Subject: RE: Camp Lejeune Vapor Intrusion Work Plan

PUBLIC HEALTH RESPONSE WORK PLAN

ATSDR received the following comments from six independent peer reviewers on the *Public Health Response Work Plan, Evaluation of Potential Exposures from Vapor Intrusion, U.S. Marine Corps Base Camp Lejeune, North Carolina.*

Figure 1A. CH2M's Vapor Intrusion Evaluation Approach* (page 1 of 3)

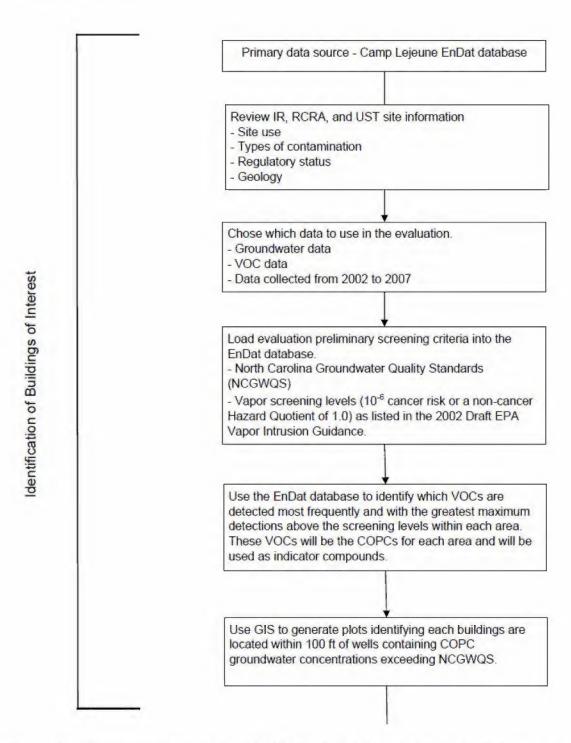
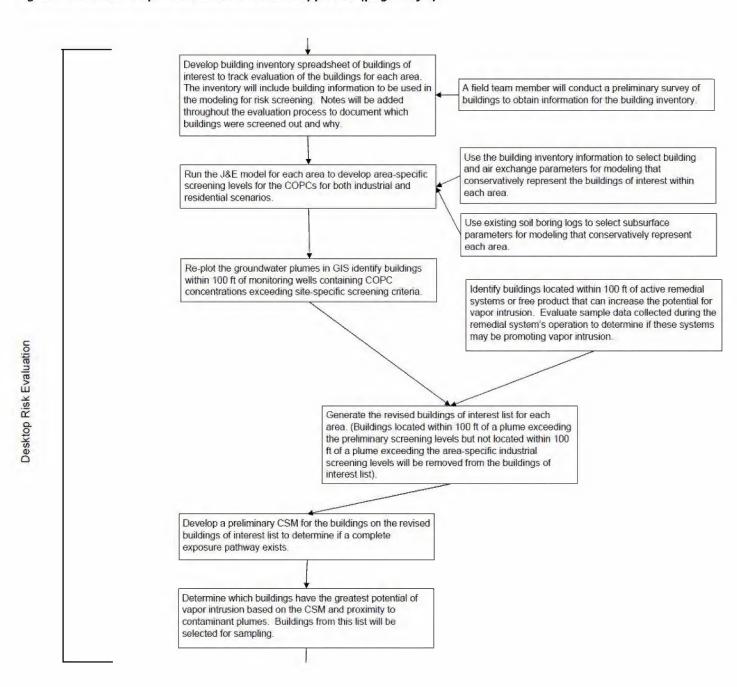
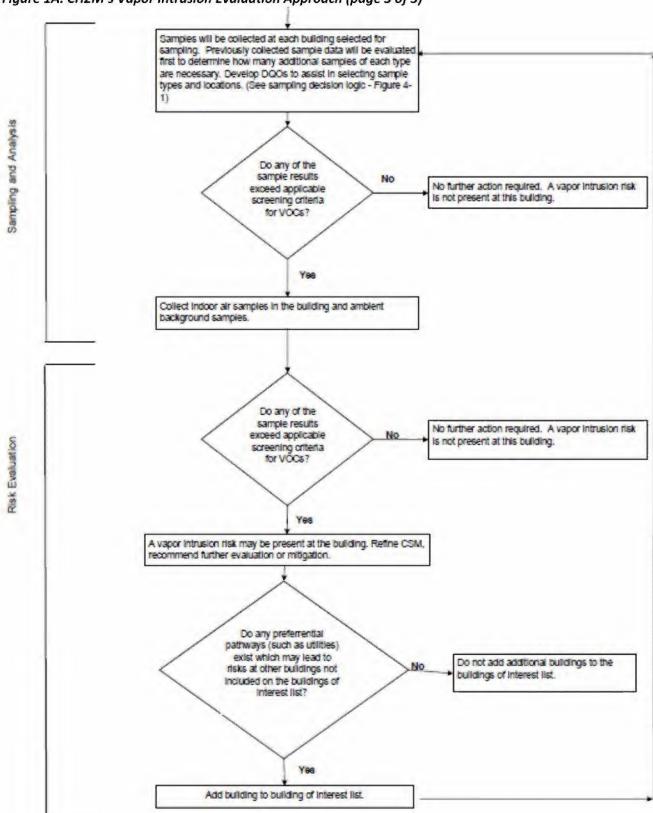
I recommend that Figure 1A in Appendix A be labelled appropriately to explicitly connect it to CH2M 's historic work/approach, rather than leave, by itself, any impression that the figure represents ATSDR's current approach, as described in the work plan.	ATSDR agrees and changed the figure title to "CH2M's Vapor Intrusion Evaluation Approach" as well as added a note to the figure stating "This figure shows the procedure CH2M followed when conducting its vapor intrusion investigation, which is different than ATSDR's approach (see also Section 2.3 of the main text)."

1	Appendix A, Figure 1A: Camp Lejeune's Vapor Intrusion Evaluation Approach (page 1 of 3) Last text block wording is odd. Might be changed to "identifying buildings that are located within 100 ft" or "identifying which buildings are located within 100 ft"	The source of this figure is a CH2M document released in 2009; ATSDR therefore cannot modify the figure.
5	Appendix B, Table 1B. Chemicals for Vapor Intrusion Assessment Identify which of these chemicals has been detected at Camp Lejeune. Also, show the CV and VICV for the chemicals.	ATSDR added Tables 9B and 10B, Appendix B, to the work plan that provides the CVs and VICVs being used to screen the Camp Lejeune data. The VI PHA itself will identify the specific chemicals that were detected, and whether they were above CVs and/or VICVs.

Figure 2A. ATSDR's Prioritization Scheme Directory Structure

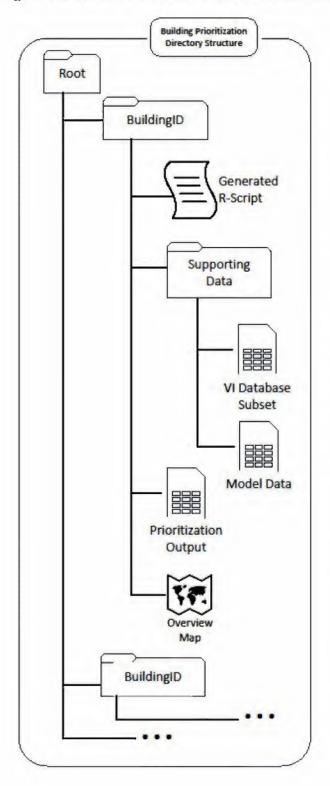
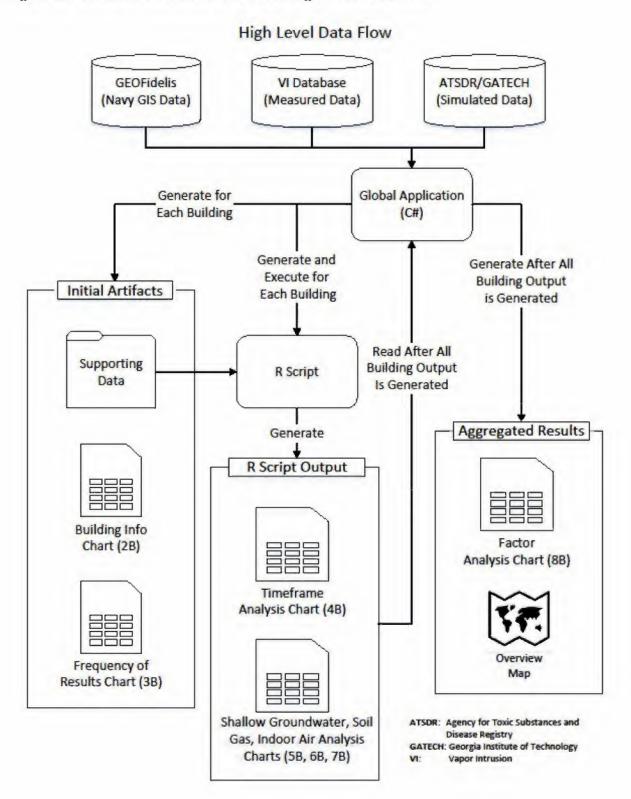
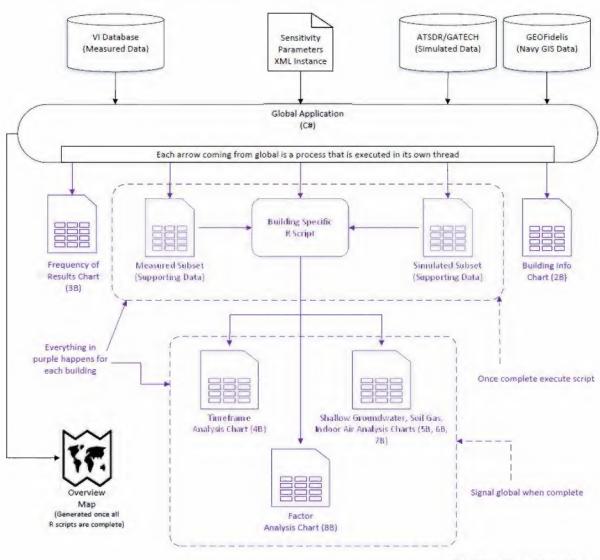
6	Provide a flowchart or graph for the overall prioritization scheme.	To show how the pieces of the Prioritization Scheme approach fit together, ATSDR added three figures to Appendix A of the work plan: Figure 2A (ATSDR's Prioritization Scheme Directory Structure), Figure 3A (ATSDR's Prioritization Scheme High Level Data Flow), and Figure 4A (ATSDR's Priority Scheme Concurrency Diagram).
	Consider ranking or weighting some of the variables in the prioritization scheme that have been shown to have a greater influence on potential soil vapor and indoor air concentrations, such as groundwater concentration or distance to building.	As stated in Section 3.1.6, ATSDR will perform sensitivity analyses. The main goal of sensitivity analyses is to gain insight into which assumptions are critical. The process involves various ways of changing input values of the computer application to see the effect on the output value. ATSDR may modify its
